CASE COMMENT REPORT

CASE NO. UDP-S25016

CASE	UDP-S25016
PROJECT NAME	The Landing, Water Taxi Terminal
APPLICATION TYPE	Site Plan Level IV
APPROVAL LEVEL	Planning and Zoning Board Review, City Commission Approval
REQUEST	Parking Reduction and Public Purpose Use for Tourist Accommodations including 21,589 Square-Foot Water Taxi Terminal, Restaurant, Visitors Center, and associated Modifications to Fire Station #49.
APPLICANT	William Walker, New Inlet LLC
AGENT	Greg Brewton, Brewton and Associates
PROPERTY ADDRESS	1001 Seabreeze Boulevard
ABBREVIATED LEGAL DESCRIPTION	Bahia Mar 35-39 B Parcel 1
ZONING DISTRICT	South Beach Marina and Hotel Area (SBMHA)
LAND USE	Central Beach Regional Activity Center
COMMISSION DISTRICT	2 – Steven Glassman and 4 – Ben Sorensen
NEIGHBORHOOD ASSOCIATION	Central Beach Alliance
SUBMITTED	April 25, 2025
COMPLETENESS ISSUED	October 3, 2025
STATE STATUTE 166.033 EXPIRATION	April 1, 2026
CASE PLANNER	Jim Hetzel, AICP, Principal Urban Planner

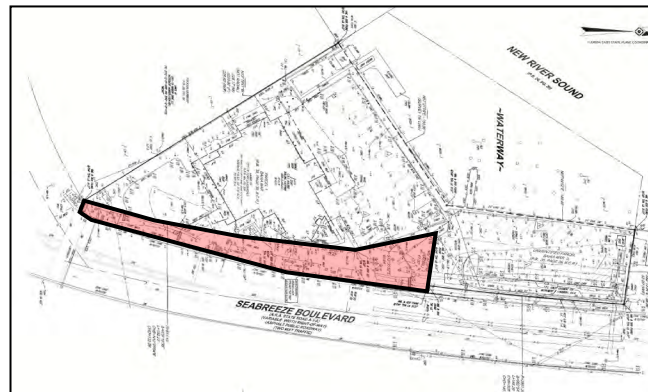
14. As proposed, there are improvements to land that is FDOT right-of-way without any communication or approval from FDOT in the submittal. Provide documentation regarding this matter. See image below with FDOT area is red. In addition, the drop-off area will require approval from FDOT as well.
